SUNDRY NOTICES AND REPORTS ON WELLS

Lease Serial No.
NM-174466 If Indian, Allottee or Tribe Name
N/A7. If Unit or CA/Agreement, Name and/or No.
NM 720018. Well Name and No.
Government "L" Com #19. API Well No.
300252560410. Field and Pool, or Exploratory Area
Bell Lake, South Morrow11. County or Parish, State
Lea, NM

Proposed Re-Plugging Program

Permanent Abandonment of Federal Wells
Conditions of Approval

Figure 4: Proposed Plugging Program for Government "L" Com #1

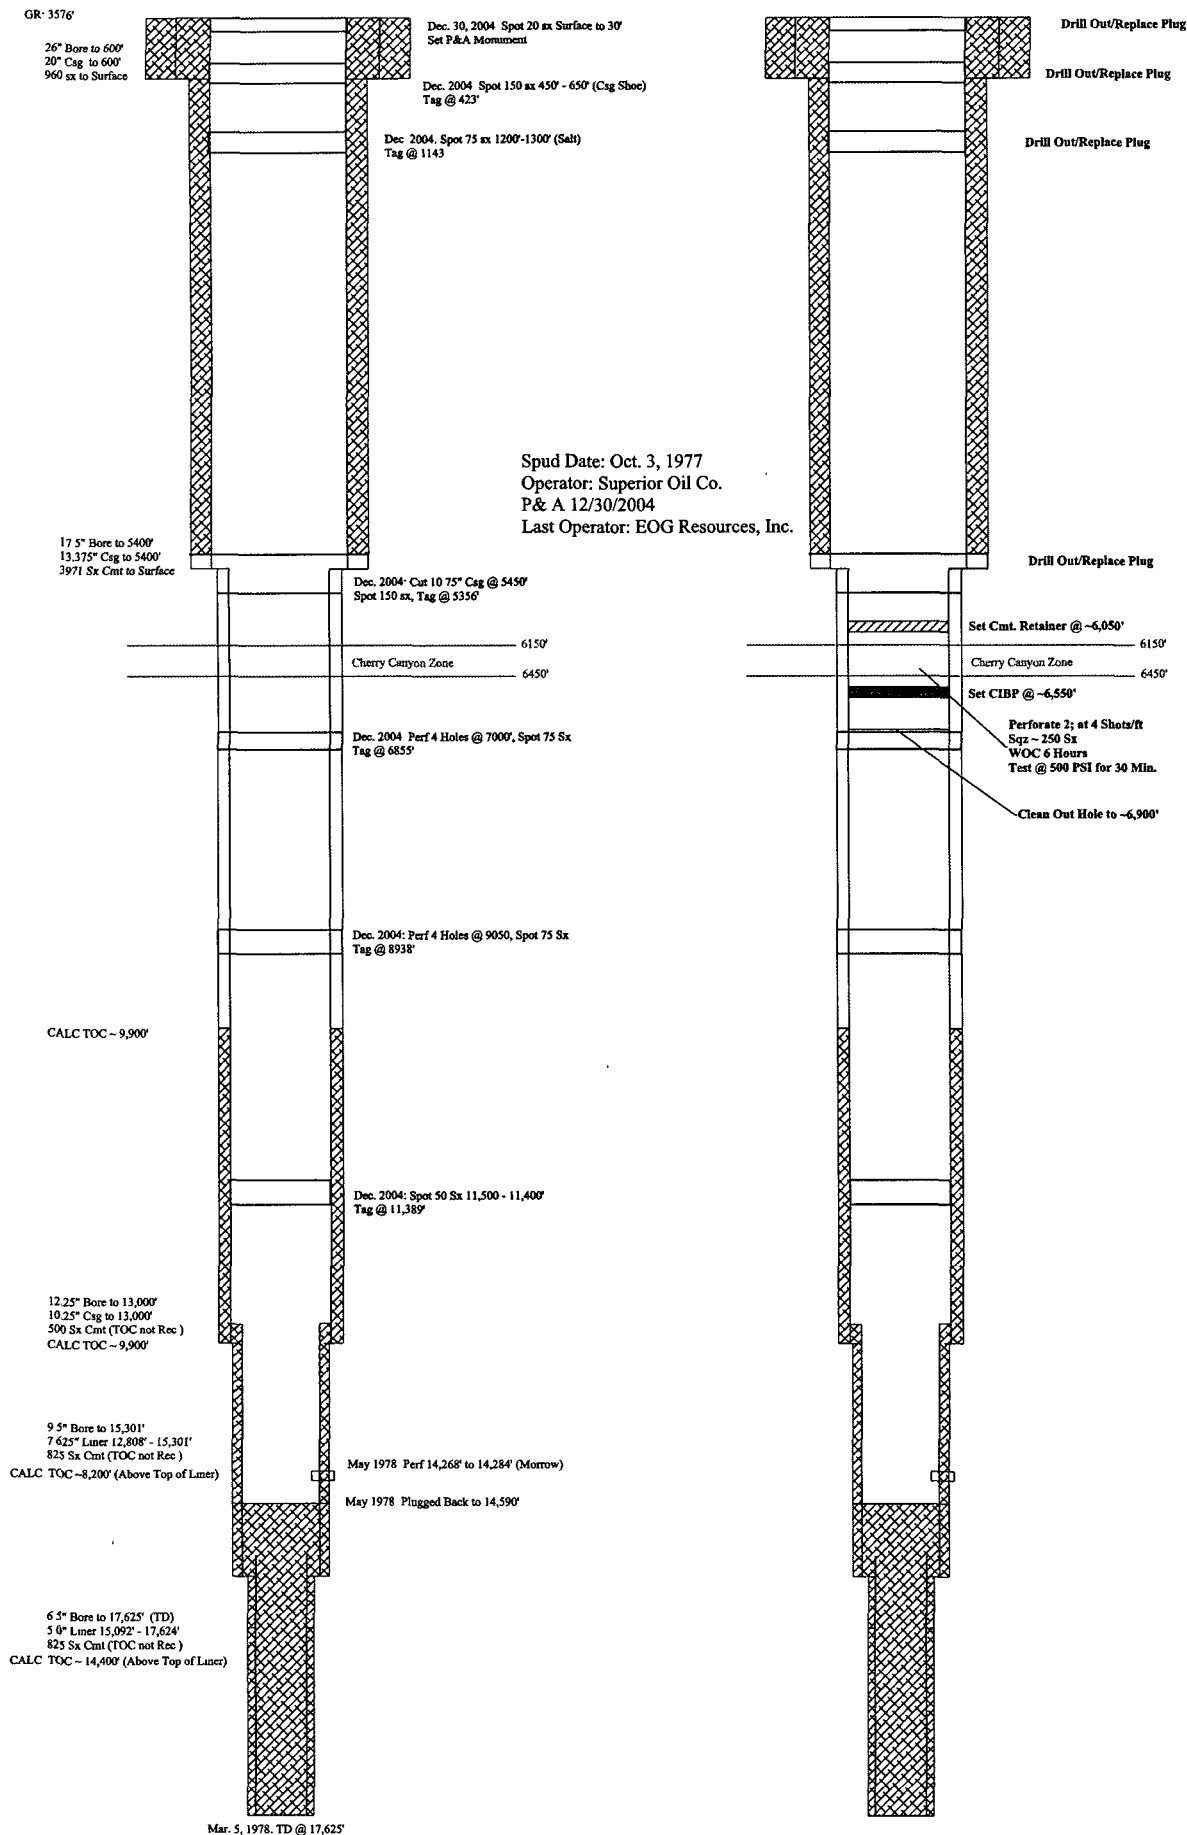
See Pg. 3 & changes

Approval subject to the following:

5. CIBP @ 6550' is optional. Perforate the 10.25" casing @ 6550 +/- squeeze adequate cement to cover 450'. WOC and tag no lower than 6100'. If tag is below 6100', re-perforate above tag and repeat. Cement retainer is not to be used for this process.

10. In addition to the placement of the plug across the Cherry Canyon, replace former cement plugs and the following additions:

Spot plug from 5500'- 5350' (10-3/4 stub and 13-3/8" shoe). WOC and tag no lower than 5350'.

Add plug across the Base of Salt, from 4840'-4690' (150'). WOC and tag no lower than 4690'.

Re-spot Top of Salt plug from 1300'-1200' (100'). WOC and tag no lower than 1200'.

Re-spot Shoe plug (20" from 979'-550'). WOC and tag no lower than 550'. Note: Question as to the actual setting depth of the 20" casing. The initial Sundry Notice dated 10/31/77 shows 94#, H-40 set @ 929.51'. The Completion Report shows 600'.

Re-spot Surface plug from 60' to surface.

11. Install bottom plate and dry-hole-marker. Reclaim site to original status.
